Customer Service BULLETIN

23811

Title Package update LDX 100

Date 2021-04-20

The block diagram below shows a typical redundant Media network setup with two Ethernet switches.

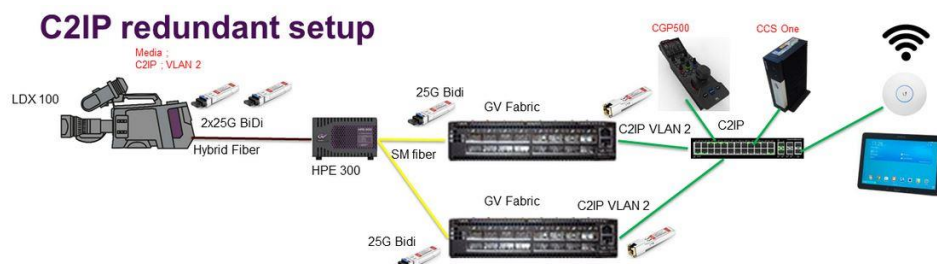
C2IP failover on primary/secondary Media network interface

With the LDX100 in Native IP mode the C2IP control interface can be embedded in the Media network interface (SFP1/2 as bidirectional 25G modules) using VLAN tags in the Ethernet packets for C2IP.

When using C2IP control of the camera over VLAN on the Media network interface it is required that C2IP control from a control panel on the management network is still available when one of the two SFP28 Media network interfaces fails.

By using a hybrid port setting of the connected port of the Ethernet switch the media Ethernet packets (audio/video/ptp) can flow on the default VLAN of the switch and the C2IP packets can be filtered on their VLAN tags and used on other tagged ports of the switch on this VLAN.

Because the control panels (CGP500 and CCS One) do not support redundancy the camera shall hard switch between the primary and secondary network interface for the C2IP Ethernet packets in case one of the interfaces fails.

VLAN tagged ports are used to create a flow for the C2IP packets to a management switch, which is used for the camera control panels.
